**KP-FHR Mechanistic Source Term Methodology
(Non-Proprietary)**

SUBJECT: KAIROS POWER, LLC - SAFETY EVALUATION FOR KP-TR-012, "KP-FHR MECHANISTIC SOURCE TERM METHODOLOGY TOPICAL REPORT," REVISION 3 (EPID NO: L-2020-TOP-0051/CAC NO. 000431)

SUBJECT: KAIROS POWER, LLC - SAFETY EVALUATION FOR KP-TR-012, "KP-FHR MECHANISTIC SOURCE TERM METHODOLOGY TOPICAL REPORT," REVISION 3 (EPID NO: L-2020-TOP-0051/CAC NO. 000431)
DATE: APRIL 22, 2022

Figure 7-8 Notation for Tritium Flows in One Node of the Downcomer Region

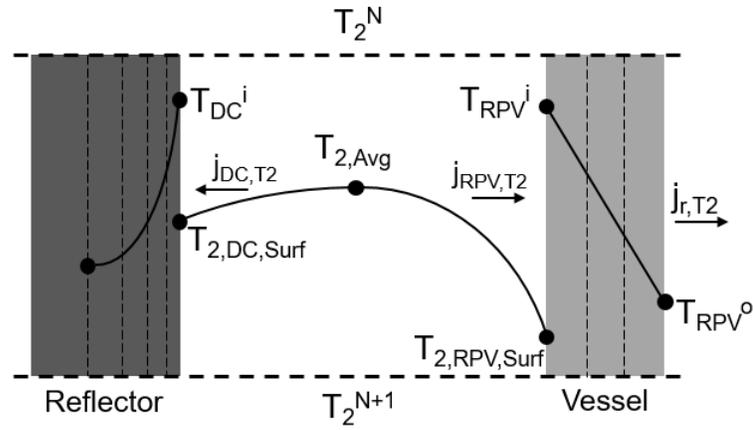
As shown in TR Figure 7-8 and Section 5.3.1, respectively, tritium permeates through the reactor vessel wall and other metals. Section 5.3.2 of the TR recognizes that tritium permeation through piping, vessels, and the intermediate heat exchanger as a unique contributor to sources of MAR for transients in the primary system is properly recognized in the methodology. For a given tritium flux, there will be faster diffusion of tritium away from the salt/metal interface and a much lower surface tritium concentration compared to the graphite case. The methodology uses Sievert’s Law for the salt/metal interface. As illustrated in TR Figure 7-8, the tritium retention in the graphite reflector is typically limited to regions near the outer surface of the reflector, which interface with the downcomer. The NRC staff notes that the mechanism for tritium retention in the reflector is similar to that in the fuel pebbles because, as noted in TR Section 3.5, the MST methodology assumes that both contain graphite IG-110.

In TR Section 5.3.2, Kairos Power models the reactor vessel downcomer as an annular flow region between the graphite reflector as the inner diameter and metallic reactor vessel wall as the outer diameter and uses Equations 67 to 71 to evaluate the tritium mass transport. Equation 67 was modified so that the Sherwood number (Sh) for mass transport in the region is obtained from an empirical correlation measured for Reynolds numbers (Re) between 10,000 and 100,000 and Schmidt numbers (Sc) between 430 and 100,000. Kairos Power provided a reference for the source of this correlation (see TR Reference 63). The NRC staff reviewed TR Reference 63 and located the correlation that is used by Kairos Power as the modified Equation 67 in TR. In evaluating Kairos’s choice among the several correlations presented in TR Reference 63, the NRC staff found that the correlation selected by Kairos Power represents

the data from all the runs in the experiment, with an average deviation of 5.4 percent and maximum deviation of 13.2 percent. This correlation is also listed in Table 5-19 of the TR Reference 60 as Item R. Based on this review, the NRC staff confirms that Kairos Power made the correct choice of correlation for the modified Equation 67 in the TR by comparing with public literature.

Limitation and Condition 10 - In any future license application submittal that references this TR, an applicant needs to provide information to justify that the calculation of tritium absorption into graphite is not sensitive to the assumptions on tritium diffusivity and solubility in Flibe.
